**RE: Candelaria & 2nd Street NW Multi-Family
210 Candelaria Rd NW
Grading and Drainage Plans
Engineer's Stamp Date: 10/27/2025
Hydrology File: G14D103
Case # HYDR-2025-00389**

GRADING AND DRAINAGE PLAN

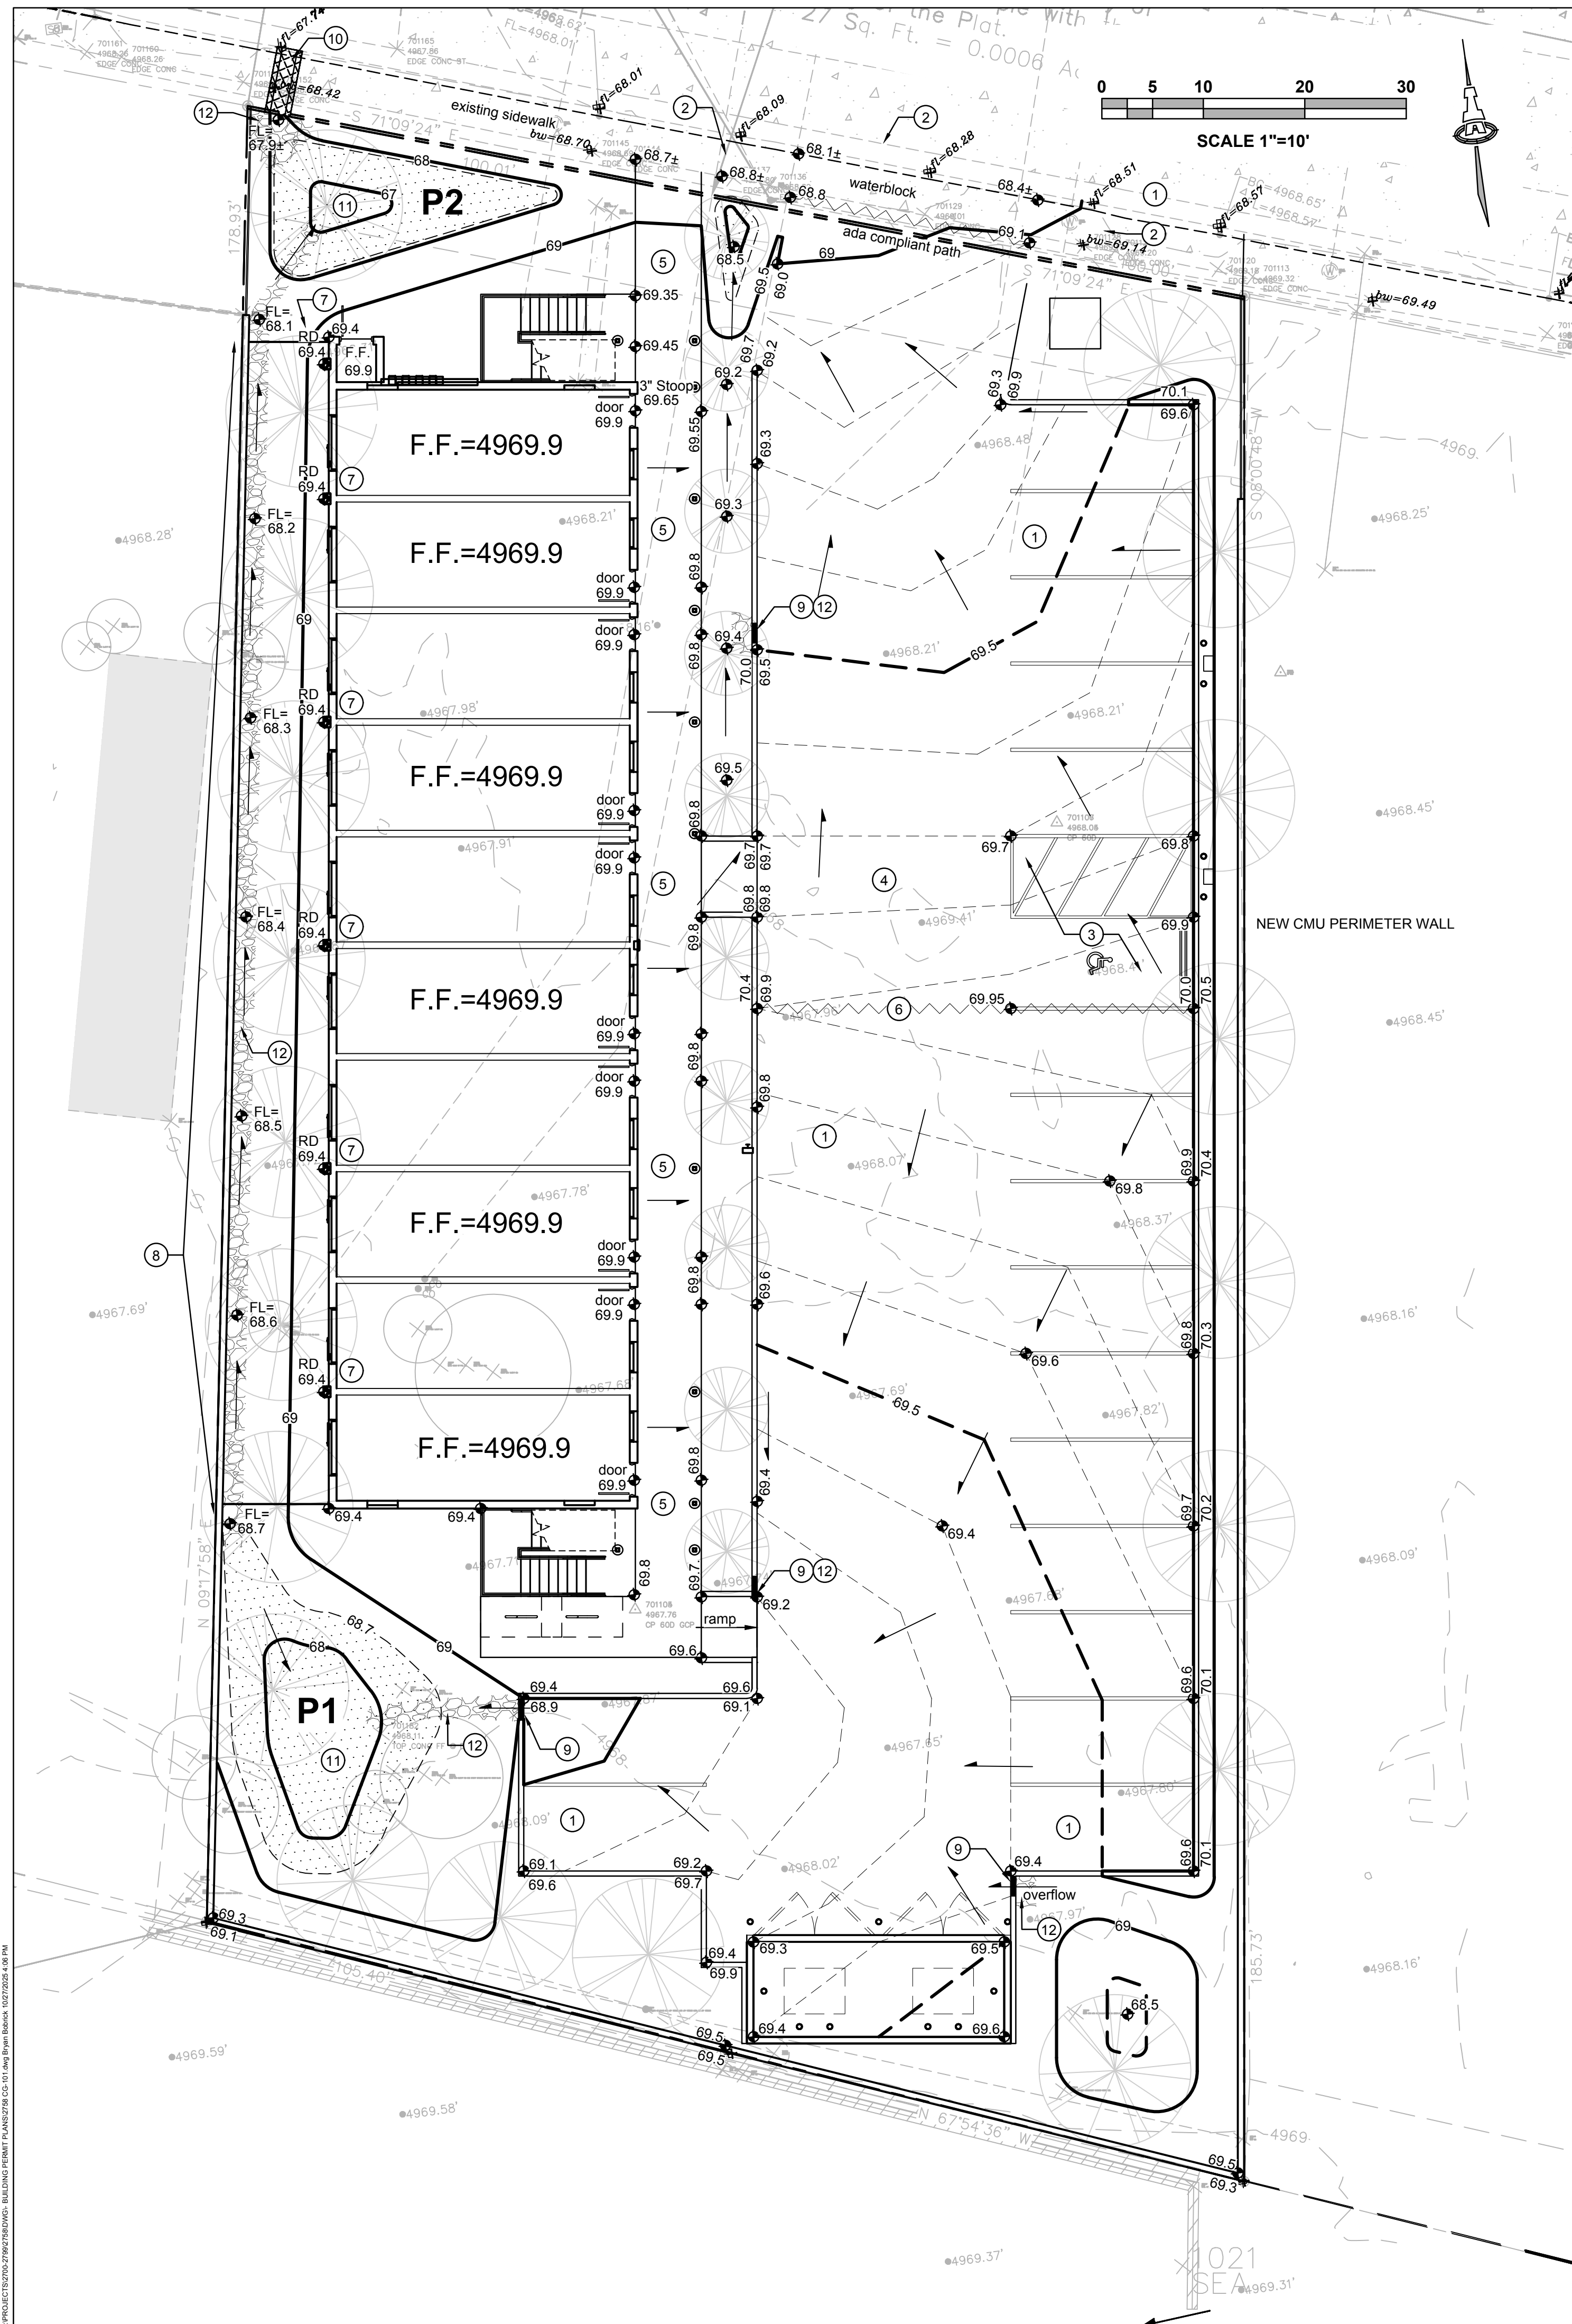
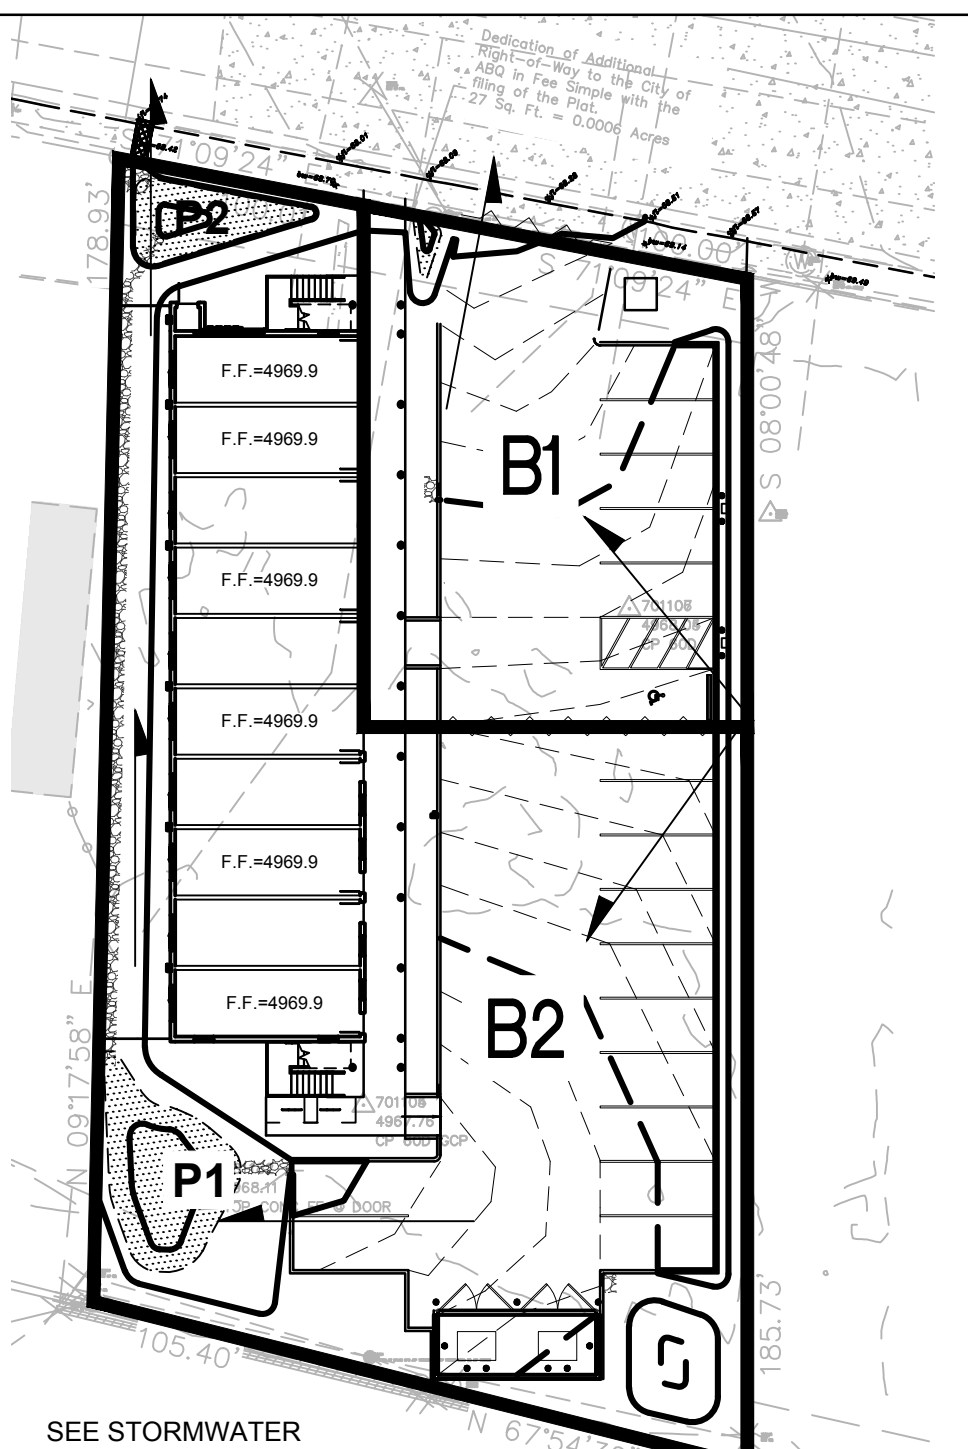
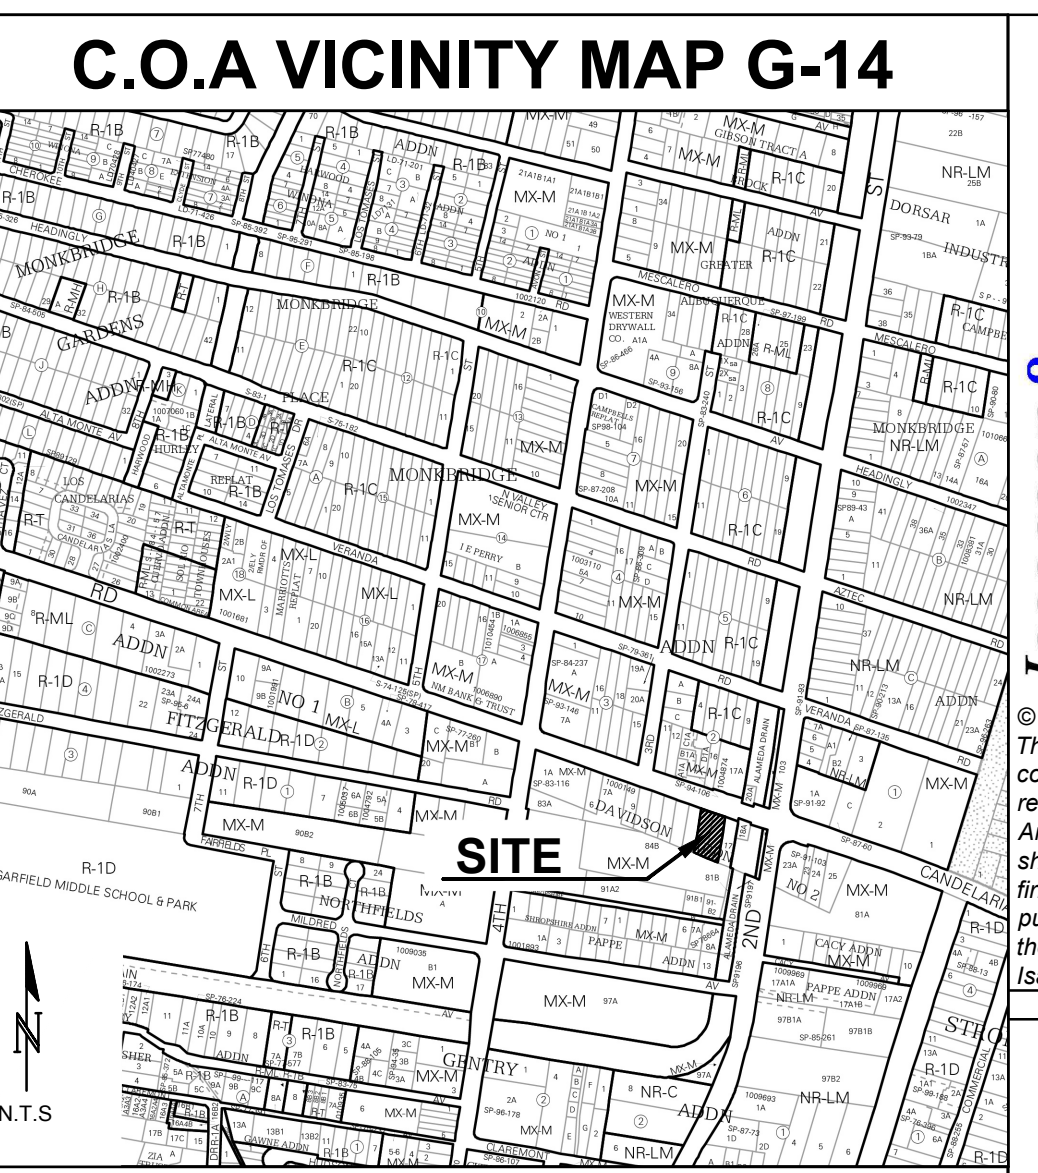
1. Please include in the Calculations Table the Existing Conditions .
2. Show the roof drain flow directions.
